**Meeting:** Traffic Management Meeting

Subject: Hitchin Road, Henlow – Consider Objection to Proposed

**50mph Speed Limit**

Report of: Paul Mason, Head of Highways

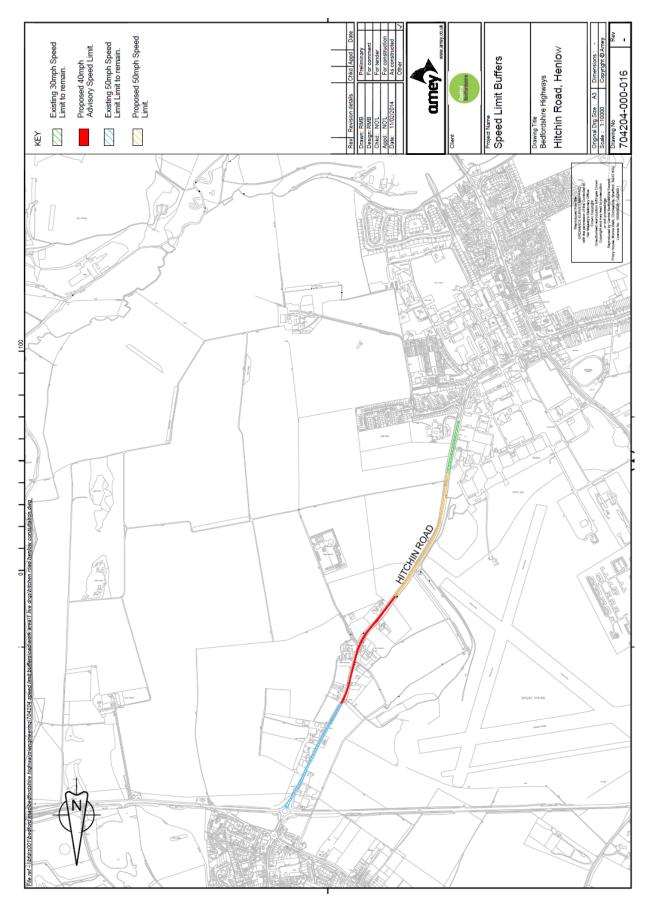
Dear Gary – Thank you for your email regarding proposed speed limits. Our Councillors have discussed the information submitted and wish to object to the proposals for Hitchin Road B649. They feel the limits proposed along the whole length travelling south ranging from 50mph at A507, then 40mph, 50mph changing then to the 30mph at Derwent Lower School is totally wrong and confusing. HPC has for some time requested a buffer speed limit of 40mph before the 30mph at Derwent Lower School – your proposals do not include for this.

The Parish Council would therefor strongly recommend, and urge you to implement, a 40 mph speed limit for the whole length of this road, from A507 to Derwent Lower School.

However I find it very hard to support this particular proposal which will result in 4 changes of speed limit in a one mile stretch from Henlow village to Henlow Camp. I think motorists will find this very confusing and I am sure it does not represent best practice.

Also this scheme gives us the opportunity to provide a 40 limit going into Henlow Camp where Derwent Lower School is situated just into the current 30 limit. Speeding is already a problem here and parents and residents will fail to understand why we will not have taken the opportunity to make this a 40 rather than 50 limit.

In summary I suggest that the whole stretch from The Crown , Henlow village to the existing 30 mph limit outside Derwent Lower School should be made 40 mph, reducing confusion and ensuring not only a safer road on the bends but also on the approach to Derwent Lower School.

I wholeheartedly support the proposal put forward by Cllr Wenham. I am also a school governor at Derwent Lower School which has an access onto the road just yards into the current 30 limit. It surely doesn't make sense to have a small stretch left unrestricted going straight into a 30.

- 5. Bedfordshire Highways' response to the points above are as follows:
  - a) The proposal is for a 50mph statutory speed limit over the whole length of road between the two existing 30mph limits on the main built-up areas of Henlow village and Henlow Camp, so should not be unduly confusing to drivers. The advisory 40mph speed limit should be seen as more of a warning to drivers that they should consider moderating their speed whilst travelling through that part of Hitchin Road where most people live.

- b) The length of Hitchin Road over which the 50mph speed limit is proposed is only sparsely built-up with minimal frontage development. The southern section has open fields on both sides. It is felt that drivers would not understand the need for a 40mph limit and consequently compliance would be poor. When considering Government advice on the imposition of speed limits, a 50mph speed limit is more appropriate for this length of road. The existing 30mph speed limit outside Derwent Lower School covers the entire frontage of the school and its main entrance is located approximately 130 metres inside the existing 30mph limit. Hence, drivers have adequate time and distance to adjust their speed if a 50mph was implemented.

- 6. It is considered that the character of the road is more suited to a 50mph speed limit and would provide an adequate buffer zone on the approach to the school.
